5.1 T210902 PA - Development of the land for thirty-one (31) dwellings at 13-15 Mahon Avenue, Beaconsfield

Recommendation(s)

That Council form a position to refuse to grant Planning Permit T210902 for the development of the land for thirty-one (31) dwellings at L1 LP46245, 13-15 Mahon Avenue, Beaconsfield on the following grounds:

Fig 5: Further elevation views of apartment buildings (as per notation)

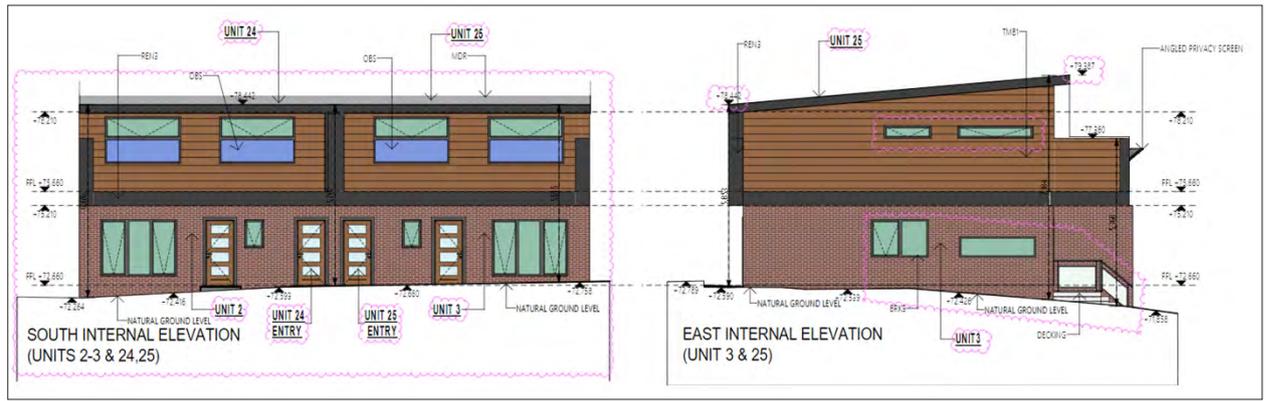
The apartment buildings are situated at the highest point of property and a ridgeline that is prominent and visible from a larger surrounding aspect, emphasising a need to have a strong response to the surrounding landscape and built form.

While the maximum heights of the buildings are not dissimilar to surrounding double storey dwellings, the tall wall heights and substantive upper storey volume act to increase the sense of size and scale to surrounding properties that is not adequately reflected in the height dimensions. These buildings are considered to have limited articulation and do not provide a suitable transition having regard to development on adjoining land.

Although there is some attempt to respond to the prevailing character of the area, the dominance in form and massing of the apartment buildings coupled with a prominent landscape location and open parking results in a design response that does not sufficiently respect the established character,
